4.0 MASTER RESPONSE 2- WATER SUPPLY AND RELATED ISSUES

MASTER RESPONSE 2 - WATER SUPPLY AND RELATED ISSUES

This master response addresses several issues related to water supply, County requirements for hydrogeologic investigations, water demand, the Salinas Valley Water Project, and project relationship to Zone 2C. Specifically, several comments expressed concerns regarding drought conditions; impacts on the adjacent Toro Area that is in B-8 zoning; loss of recharge to the Toro Area; acceleration of seawater intrusion and overdraft of the Salinas Valley Groundwater Basin; viability of the SVWP; conservation requirements; annexation of the project site into California Water Service Company's service area; and arsenic levels.

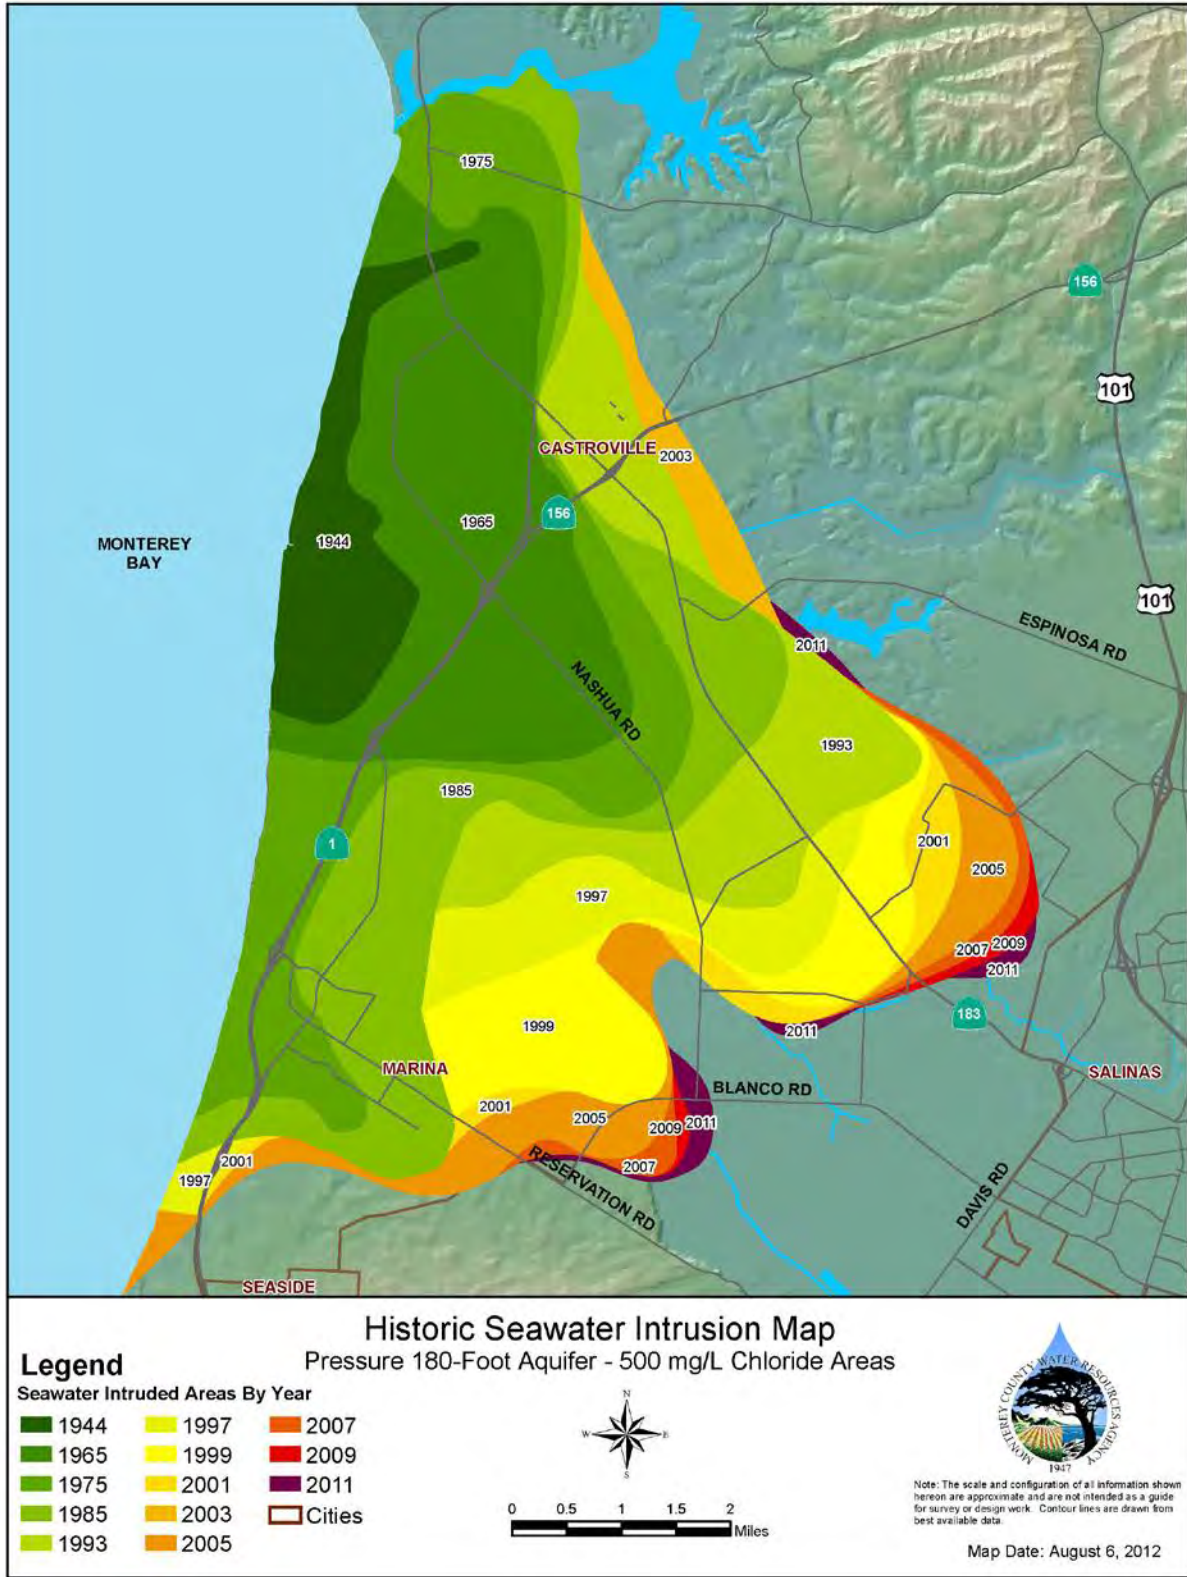
A commenter questioned whether the Project Site should be included in Zone 2C. The Toro/Fort Ord area was added to Zone 2a in the 1990's. Figure 3.6-6 of the DEIR shows the subject site is clearly within the boundaries of Zone 2c. In addition, the attached figure taken from the Monterey County Water Resources Agency shows the site was in Zone 2A prior to its expansion to include Zone 2C. The entire project site is within the Zone 2C boundary. An additional exhibit is attached.

Historic Seawater Intrusion Map
Pressure 400-Foot Aquifer - 500 mg/L Chloride Areas

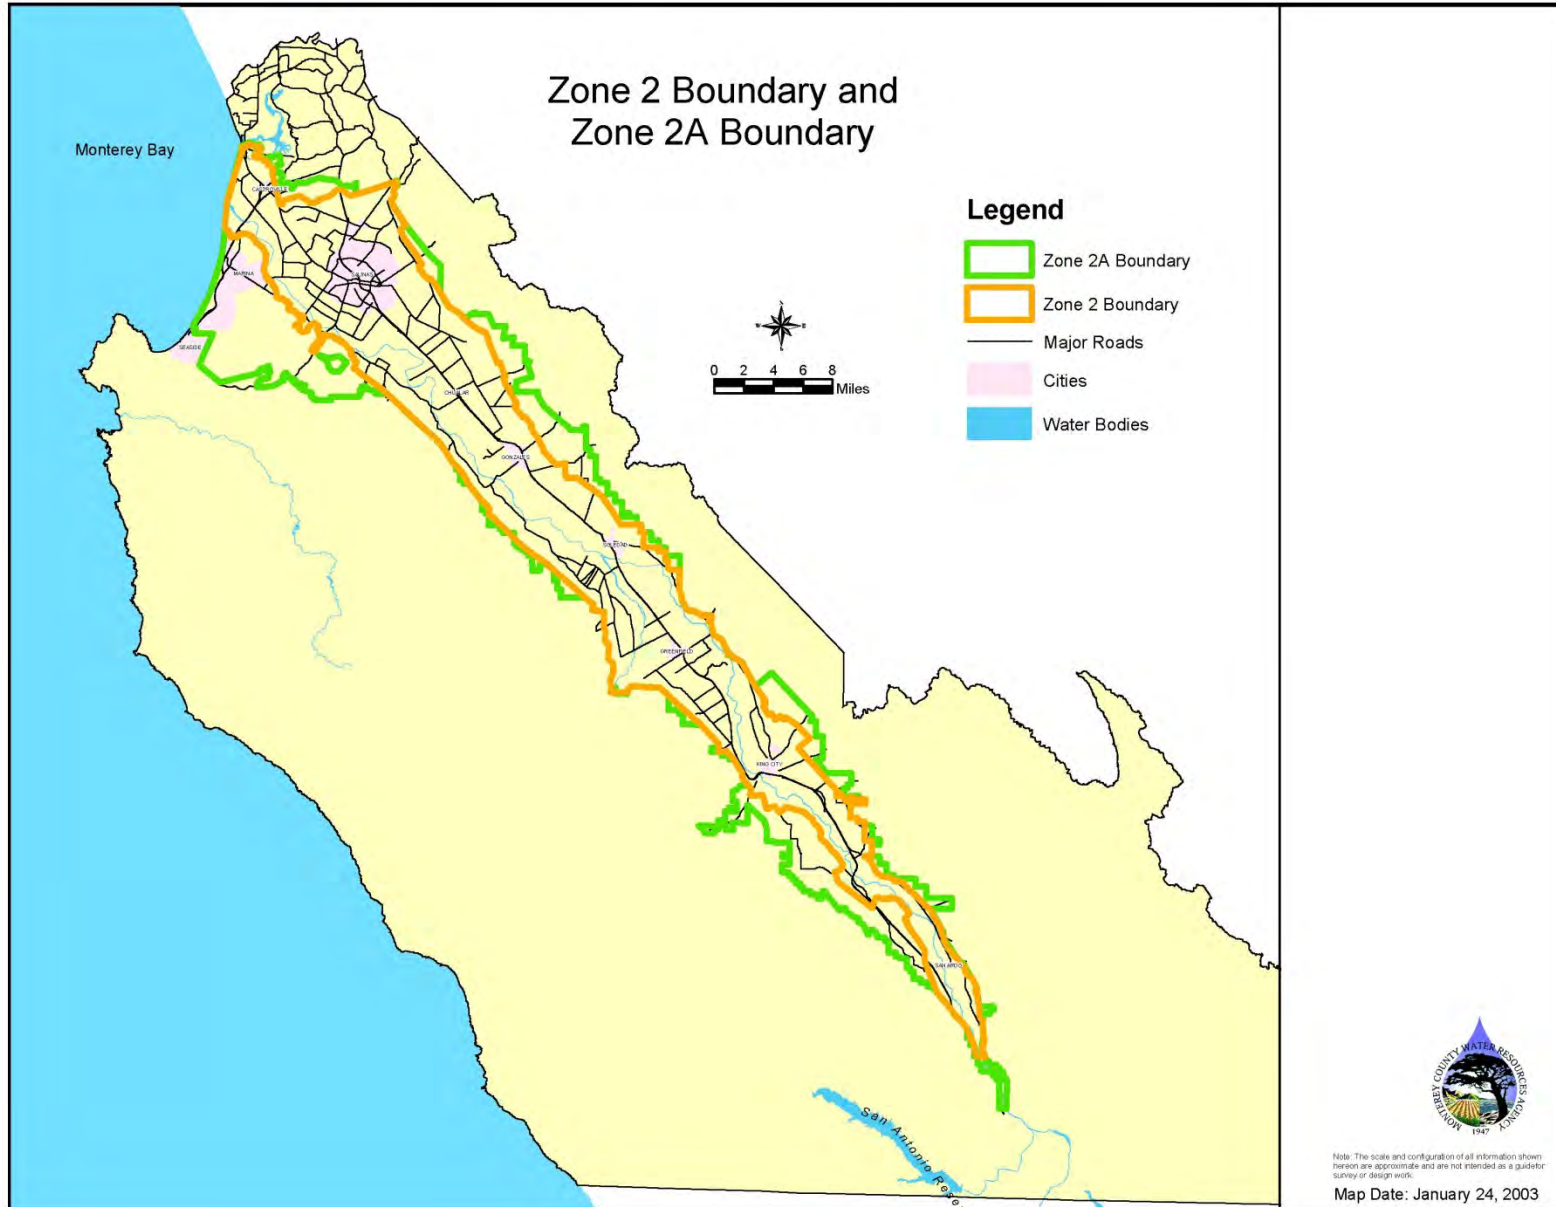
As identified on page 3.6-9 of the DEIR, the project water source, the 180/400-Foot Aquifer, a subbasin of the SVGB has an estimated total storage capacity of approximately 7,240,000 acre-feet of groundwater. As identified in the DEIR (page 3.6-1) and its supporting reference documents, the Salinas Valley Groundwater Basin as an entire unit is in an overdraft condition; however, some subbasins have better groundwater yields than others. The 180/400 Foot Aquifer Subbasin is recognized as a subbasin that has historically experienced overdraft conditions and, as a result, saltwater intrusion has progressed (DEIR 3.6-15).

The project is estimated to have a total demand on this subbasin of 95 acre feet per year. The DEIR found this demand on the subbasin was less than significant due to a combination of factors. First is the insignificant demand (95 acre feet per year) versus the total storage capacity of the subbasin (7.24 million acre feet per year). Second is the small demand of this project (95 AFY) in relation to the overall annual demand for the subbasin in 2005 of 118,372 AFY (Agricultural Pumping: 97,028 and Urban Pumping 21,344 (Monterey County Water Resources Agency 2007).) It should be noted that the total pumping from the SVGB is 500,000 AFY with a 90/10 split between agriculture and urban uses. Third is the consistency with the CWSC Urban Water Management Plan, and fourth is the positive influence of the suite of projects implemented to combat seawater intrusion; the Salinas Valley Water Project, CSIP, Lake Nacimiento and Lake San Antonio. DEIR page 3.6-17 provides graphs demonstrating that the rate seawater intrusion has been slowing since 2005. The most recent data from the MCWRA shows a continued slowing of the seawater intrusion. These maps are attached on the following pages.
